COMPLIANCE REVIEW COMMENTS/CORRECTIONS

Case Number:	Administrative Approval 22ENT-0073
Location/Zone:	2601-2645 Lincoln Boulevard
Proposed Project:	<p>Tier 1 with State Density Bonus project consisting of a 5-story, 65-foot tall, mixed-use housing project. The project is comprised of 521 residential units (468 market rate + 53 very low-income affordable units), 36,600 square feet of neighborhood serving commercial (retail, restaurant, and grocery store), 850 automobile parking spaces and 822 bicycle parking spaces.</p> <p>State Density Bonus Incentives and Concessions requested with application:</p> <ul style="list-style-type: none"> (1) Increase in maximum building footprint; (2) Relief from AHPP requirement to provide all 2-bedroom affordable units (SMMC Section 9.64.050.E); and (3) Increase in maximum ground floor commercial height to accommodate residential and market loading <p>State Density Bonus Waivers of Development Standards requested with application:</p> <ul style="list-style-type: none"> (1) Increase in height in feet from 36 to 65 feet; and (2) Increase in number of permitted stories from 3 to 5

22ENT-0073 | 2601 Lincoln Blvd | 521 residential unit, Mixed Use Develo

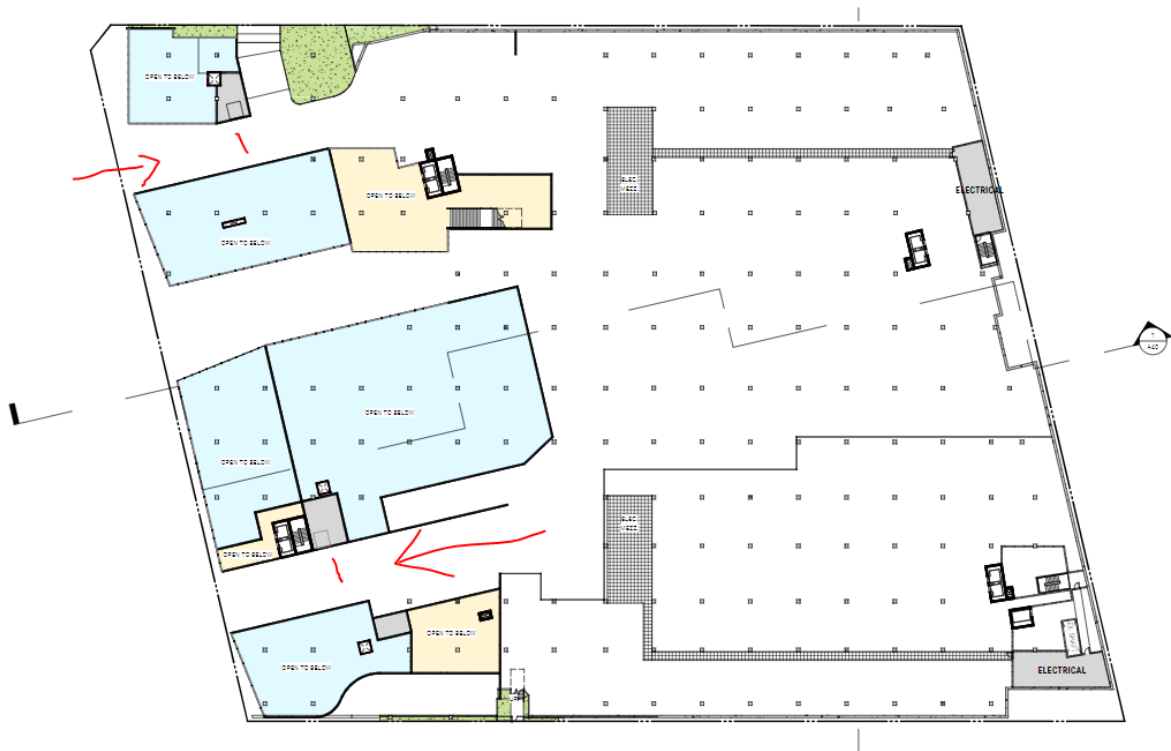
The design proposes separate Commercial and Residential RRR rooms.

The commercial uses are served by 2 RRR Rooms adjacent to the portion of driveways that are open to the sky. Collection can occur in the 25' wide driveways and the trucks can then circulate around through the parking structure which will have a minimum of 14' clearance.

Comment: we need to figure out the drive path for each entrance, I totally forgot to mention it in our meeting, our collection vehicle(s) cannot go against traffic. RRR vehicle needs to stay on the correct side of the drive isle when servicing the location. see below.

Does this arrangement work for RRR? **YES subject to 15' clearance requirement.** Are the rooms proposed adequate in size? **Yes** Since this involves food waste can multiple collections per week be provided? **Yes**
Correct.
